CERTIFICATE OF APPROPRIATENESS PLACARD

COA-0064-2020

Raleigh Historic Property:
Community Services Center
401 E. Whitaker Mill Rd., Raleigh NC

Re:
Community Services Center Renovation
401 E. Whitaker Mill Rd., Raleigh NC
COR Plan No.COA-0064-2020

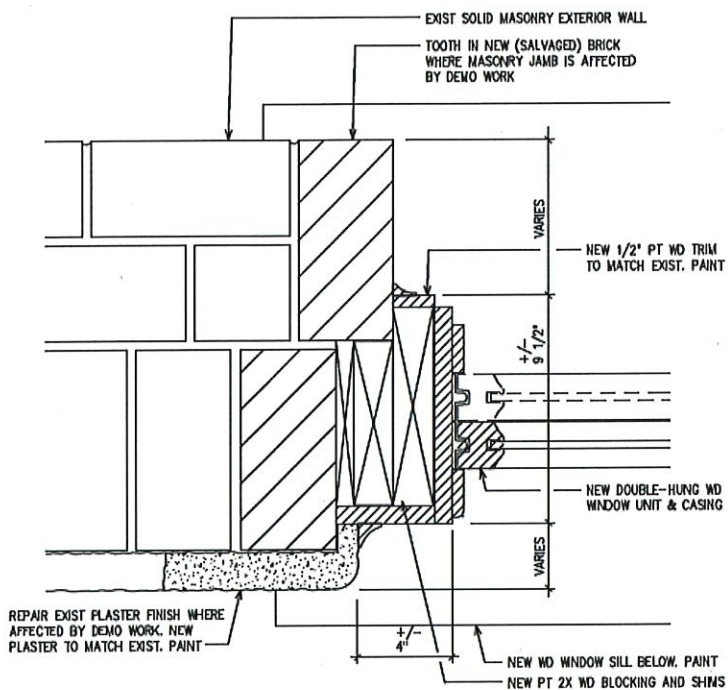
Could you provide a closer photograph of the door? As above, pending receipt of window specifications and the closer photo of the door, this can be approved.

Please see the requested photo below. Please note the concrete lintel size in relation to the door and the infill masonry on the right side of the frame. It indicates that the door was not part of the original design and more than likely it replaced the original double hung wood window.

Our intention is to restore the façade to the original design intent and install again a new double hung wood window matching the lintel size and adjacent windows design, as per specifications and details included in the response to question no.2.

F1 WINDOW JAMB DETAILS - 1ST FLOOR
3" : 1'-0"

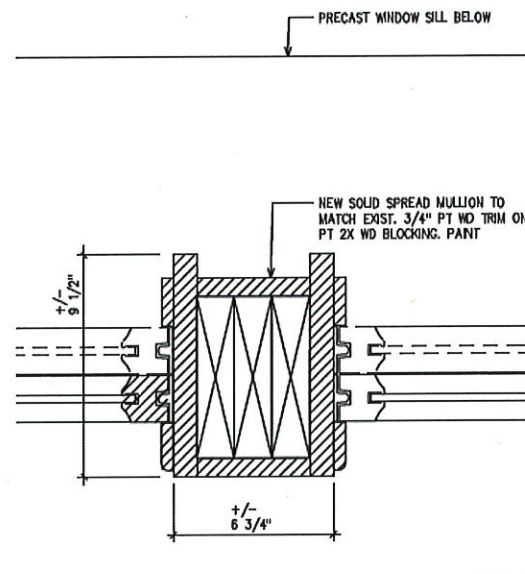
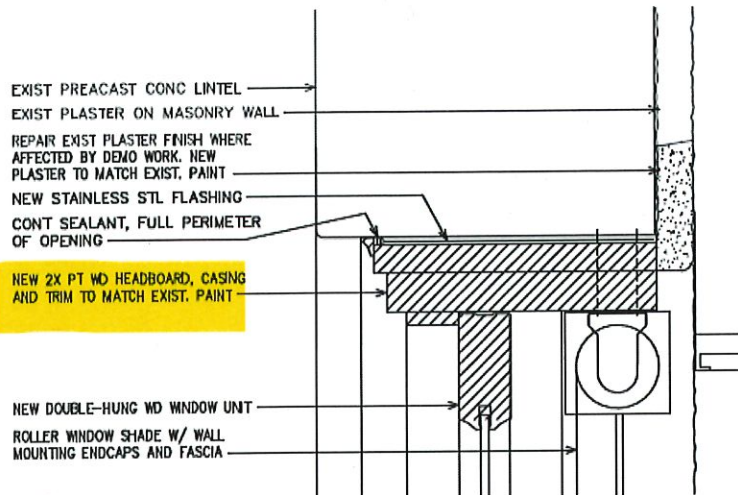
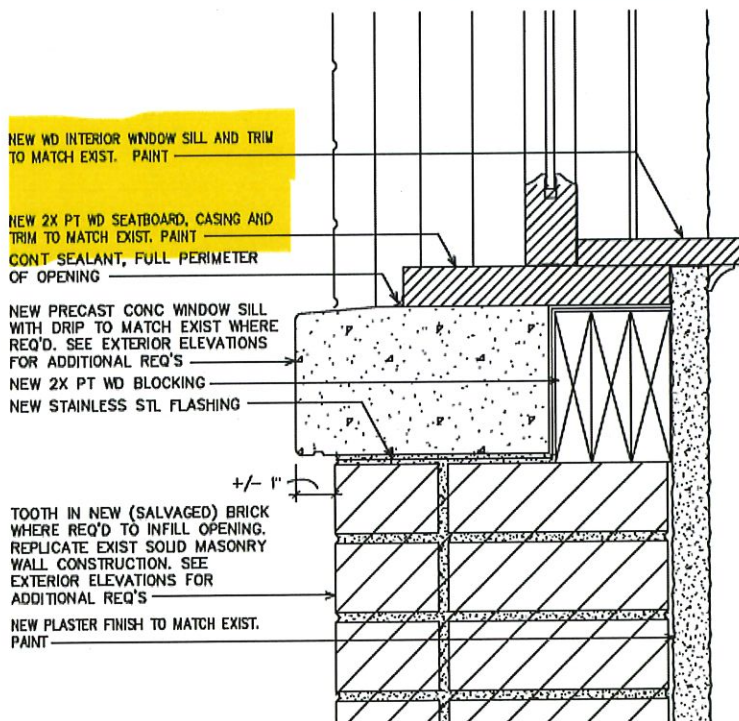
2. Metal Window Replacement and Fire Exit Door conversion:
Please provide manufacturer's specifications for the windows. Pending receipt of that information, this can be approved.

This is a public project and therefore the specifications are written in a non-proprietary format with three or more brand names/manufacturers included.

In order to ensure that the new windows follow the RHDC Guidelines (new features to "match the original feature in design, dimension, detail, color and material") we've included the following provisions in the project specifications, Section 085200 – Wood Windows:
(full Section 085200 attached)

Also, our drawings include precise construction details which match existing double-hung wood windows design. Please see below.

Existing conditions
(multiple locations on East and West elevations)

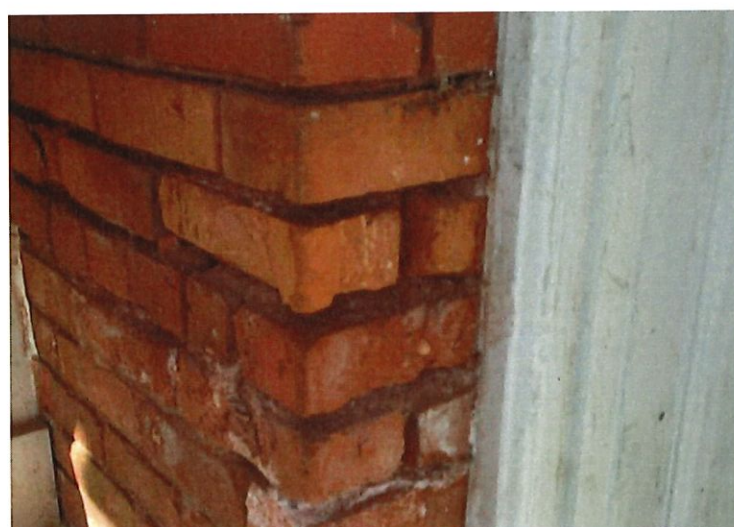
Could you provide a before and after photo of the previous work on the east or west elevation that you plan to match? Pending receipt of that information, this could be approved. Please keep in mind **Design Guideline 2.2.5: "Repoint masonry mortar joints if the mortar is cracked, crumbling, or missing or if damp walls or damaged plaster indicate moisture penetration. Before repointing, carefully remove deteriorated mortar using hand tools. Replace the mortar with new mortar that duplicates the original in strength, color, texture, and composition. Match the original mortar joints in width and profile."**

East and West elevations haven't been recently (or ever?) tuckpointed. We're not sure if the existing masonry mortar is original or there was some restoration work done at one point in time. The existing mortar is cracked or missing in multiple locations and needs to be restored, see photos below.

Window plan detail
Sash replacement shown with **bold** lines

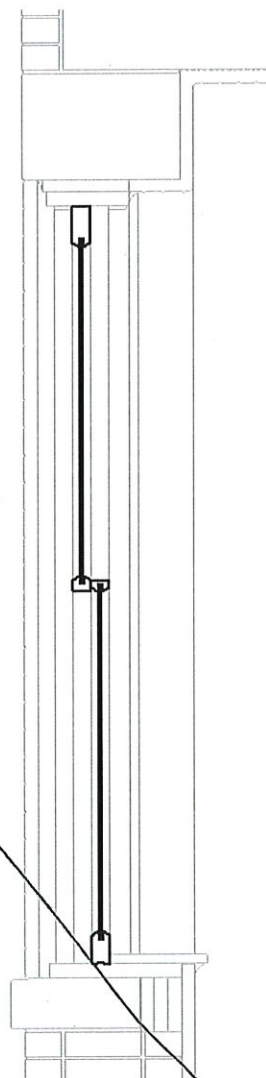
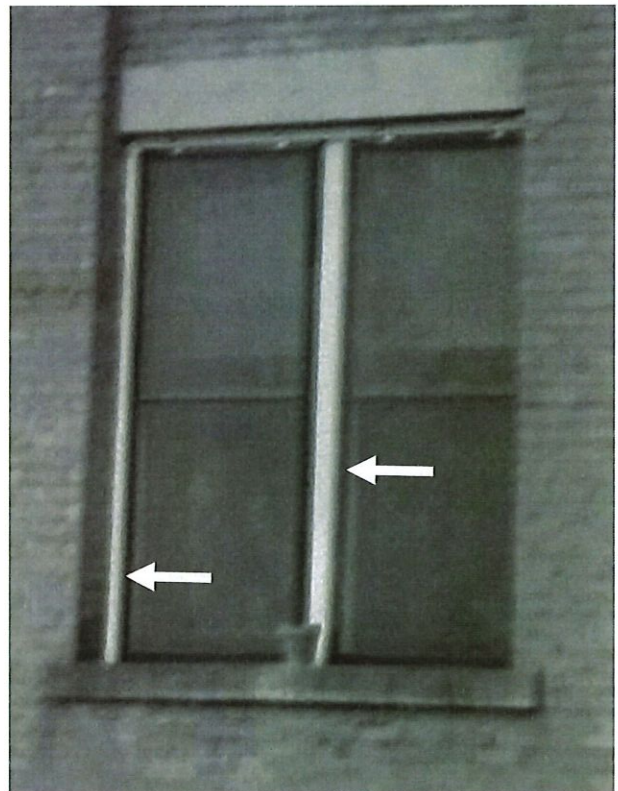
Thanks for the additional materials. With the new information, we can approve all parts of your application except for the window sash replacement. As staff, our ability to review and approve work items is limited. As I mentioned previously, we can only approve replacing windows or exterior components of windows with clear evidence that they are damaged or deteriorated beyond repair. This evidence would include detailed photographs of each sash to be replaced and an assessment by a preservation professional that the windows cannot be repaired. Alternatively, you could also provide evidence that the sashes to be installed are identical (matching in dimension, design, material, quality of material, and other visual qualities) to those being removed. Without the submission of either form of evidence, the window sash replacement must be reviewed by the Committee as a major work COA.

Our intention is not to replace the entire window. Only the sashes will be replaced with matching components. The existing window frames, mullions, sills, interior and exterior trim remain, and will be repaired as needed and painted. The exterior building appearance will remain unchanged.
